**SUBJECT: 125 DOVER COAST BLVD. - NORFOLK, ON
SOUTHBRIDGE PORT DOVER - LONG TERM CARE HOME
PROJECT NO. SPPL2026106
BUILDING PERMIT COMMENTS AUGUST 5, 2026
BUILDING APPLICATION NO. PRBD20260739
GWAL PROJECT NO. 2026-199**

To: Kendall Wharton, Planner
From: Development Engineering Department
Date: Aug 5, 2026
E-mail: developmentengineering@norfolkcounty.ca
Re: SPPL2026106 (125 Dover Coast Blvd, Port Dover)

Development Engineering has reviewed the **1st submission** for **SPPL2026106** and have the following Comments:

Water Meter & Backflow Prevention Scenarios for Commercial Industrial and Institutional Buildings

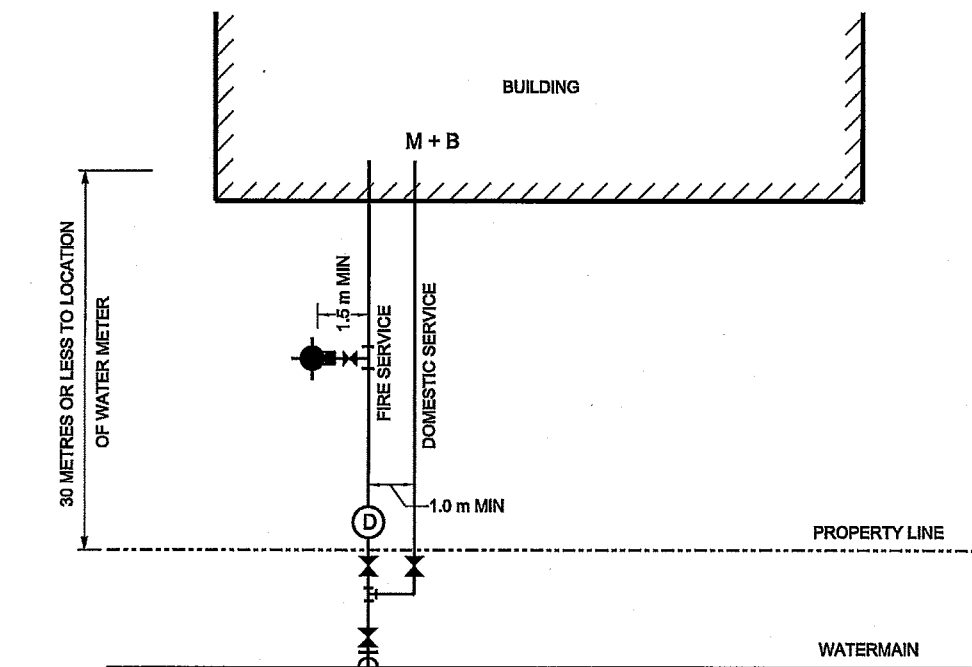
5. To be read in conjunction with GEI Comment 16, Norfolk County is attaching an example of standard domestic and fire water servicing. Please review Scenario 6.

6. As identified in Scenario 6 a Detector assembly will be required immediately past property line on the fire service.
7. As identified in Servicing and SWM report 2.2.2 Fire Protection system, the proposed building is to be sprinklered. As shown in Scenario 6 the Fire line into the building must be separated from the Domestic water service. Please review and provide a separate Domestic and Fire service into the proposed building.

- Item 5: Civil and mechanical plans to be updated to provide a dedicated water connection to the fire protection and domestic services separately within the building.
- Item 8: The proposed mechanical room is adequately sized to accommodate the domestic water backflow preventor and meter.

DRAWING NAME	PROJECT NO.
GRADING PLAN	126012-00
REV # 4	DRAWING NO.
126012-GR

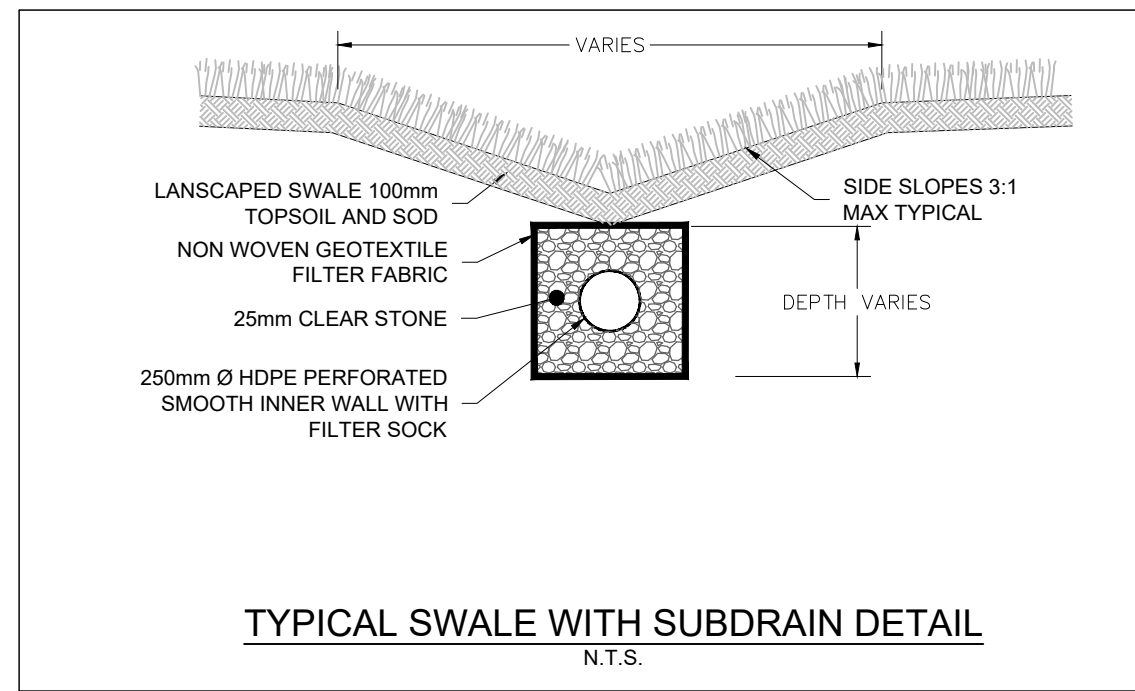
4. In the GEI review, it is recognized there are several concerns with overall Lot Grading. In the County's review it appears this submission is attempting to match existing property line grades surrounding the development. However, some of the surrounding lands have only been rough graded after road construction. The existing lands have not been graded to the ultimate design. Please review the attached "Overall Grading Plan – Sheet M32" from the original Dover Coast Development drawings. In your next submission the Lot grading plan shall conform to the overall grading plan.

Novatech Response: We have reviewed Overall Grading Plan – Sheet M32" from the original Dover Coast Development drawings. The revised Grading Plan aligns with the ultimate design grades along the future development to the north. The proposed grades along the existing residential houses to the south match into the existing. The proposed grades along Dover Coast Boulevard and Barrett Court match the design cross sections with a 2% slope from property to top to top of curb. The proposed grades along Highway 6 have been designed to assure no water from the highway flow towards the site.
